City of Franklin
Economic Development Commission (EDC)

CITY OF FRANKLIN

Special Use Amendment

Project Name:	ChromeTech Special Use Amendment
Project Address:	10020 South 54 th Street
Applicant:	Zar, LLC
Owners:	Zar, LLC
Current Zoning:	Planned Development District No. 7
Future Land Use:	Commercial
Use of Surrounding Properties:	Industrial to the north, south (vacant land), east and west
Applicant Action Requested:	Recommendation of approval for the proposed Special Use Amendment to the Common Council.

Date: 10-2014 Drawn By: B. Zenker
 Sheet Title: UTILITY PLAN
 Sheet Number: C-103
 Project Number: 4406

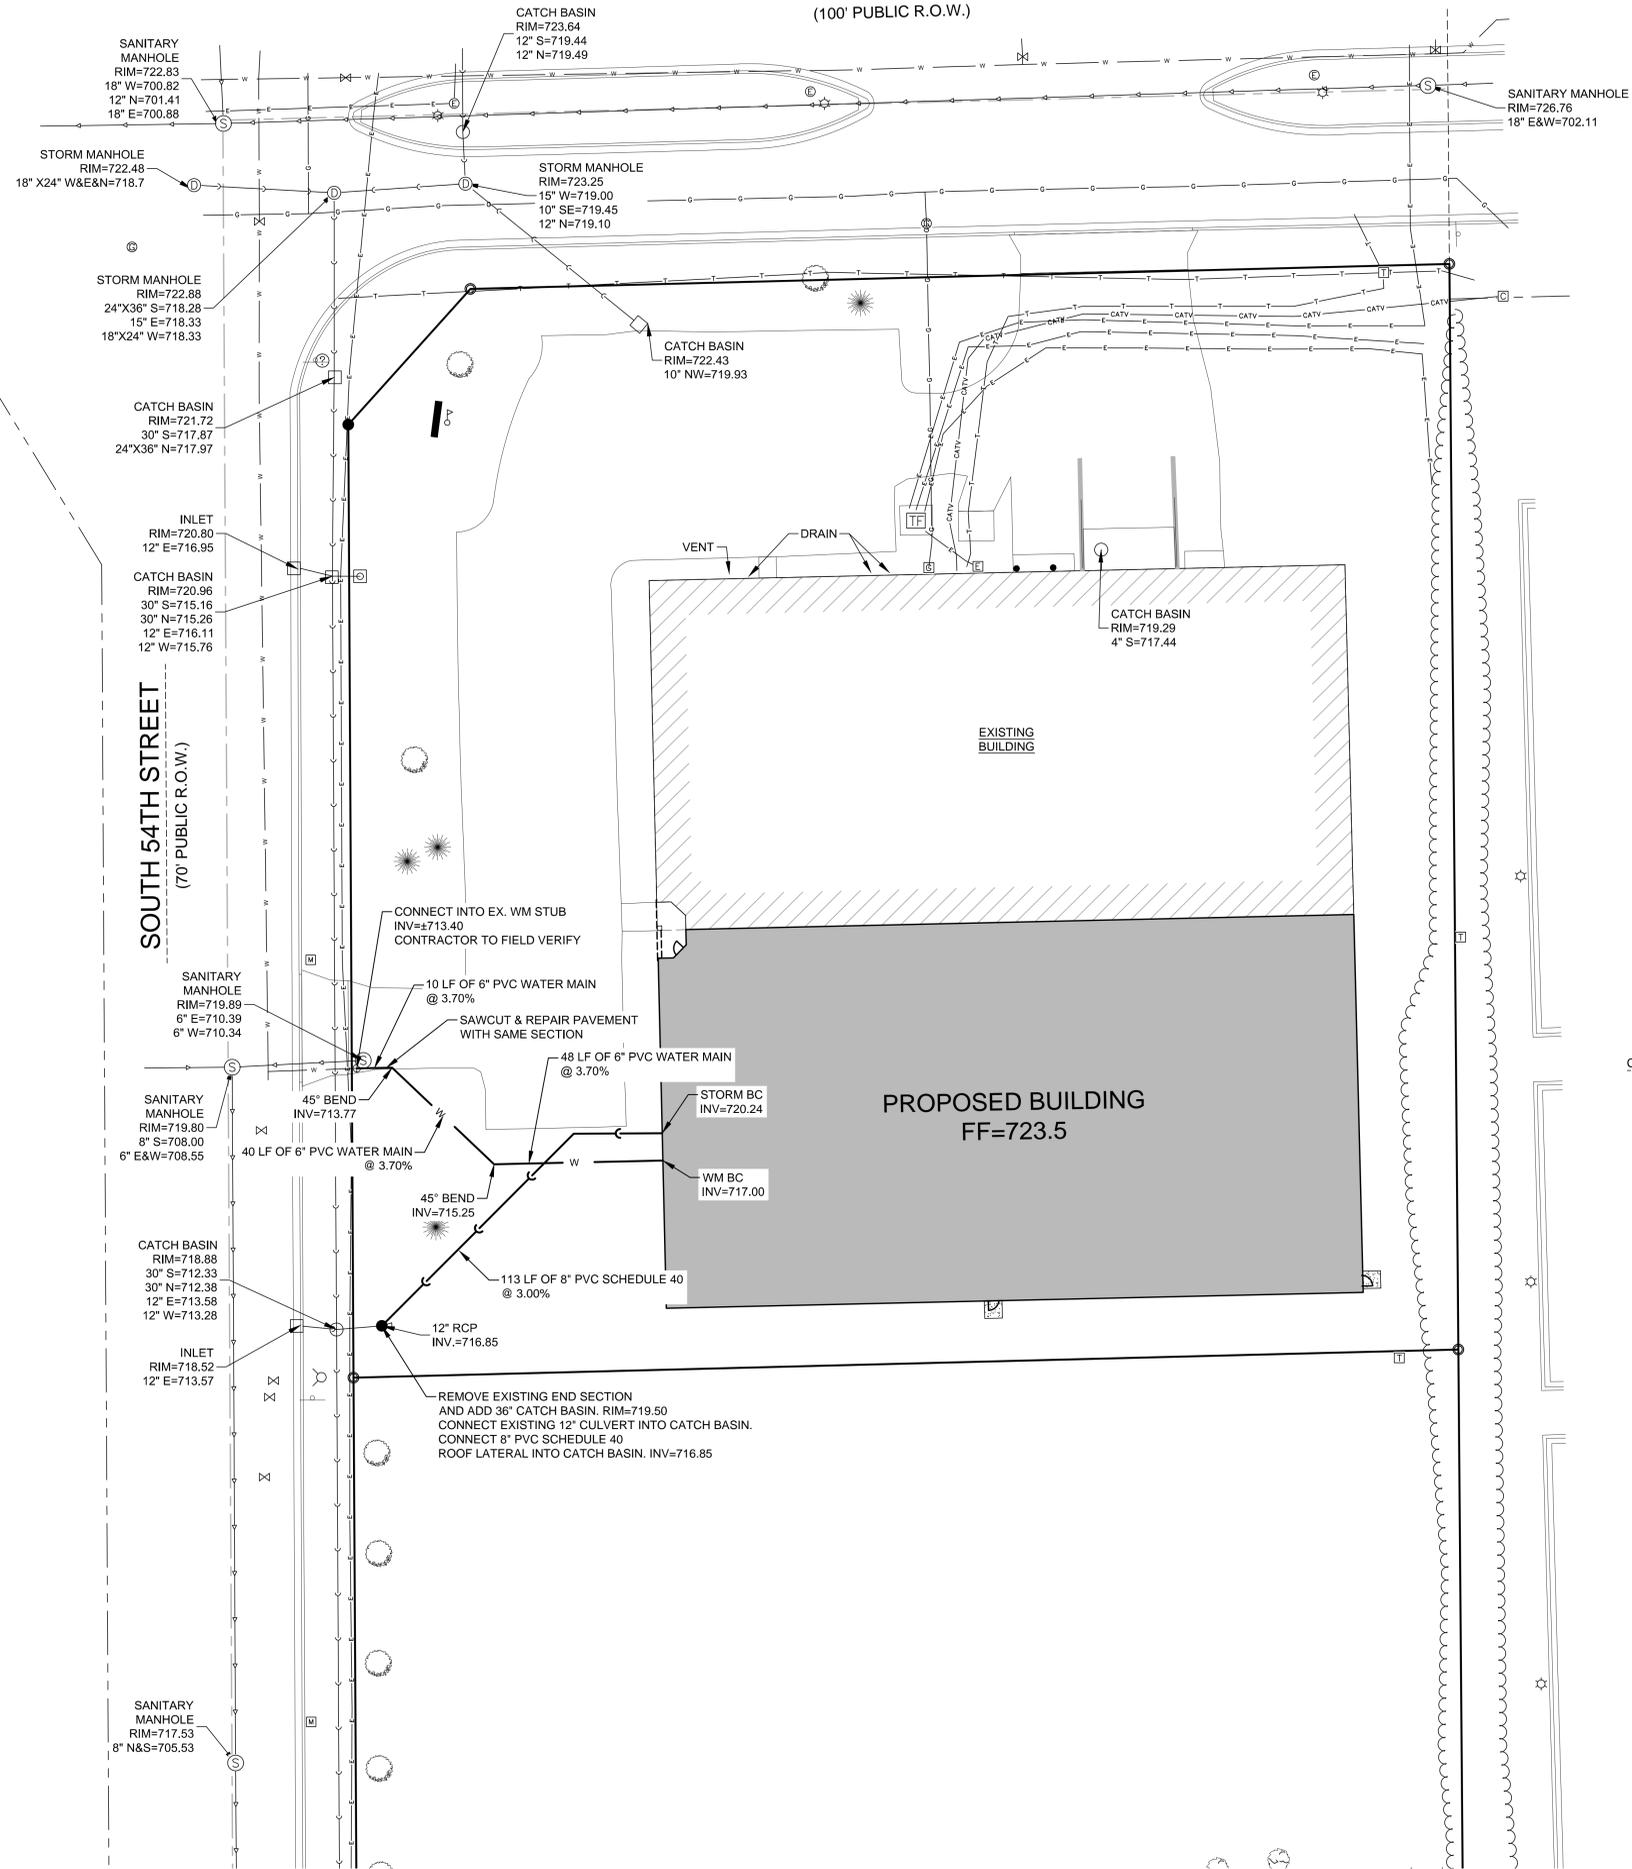
1. The applicant must comply with the State and local fire codes and that the existing water service connection is not adequate for fire protection.
2. A structure or field inlet should be constructed east of the existing catch basin. The applicant should then connect the proposed roof drain or downspout and extend and re-use the 12" RCP end-section to take the storm drainage run-off around the easterly and southerly drainage swale.
3. The drainage swale must be constructed within the property.

1. The applicant shall address Fire Department staff comments to the satisfaction of the Fire Chief, prior to the issuance of a Building Permit.
2. The applicant shall address Engineering Department staff comments to the satisfaction of the City Engineer, prior to issuance of a Building Permit.
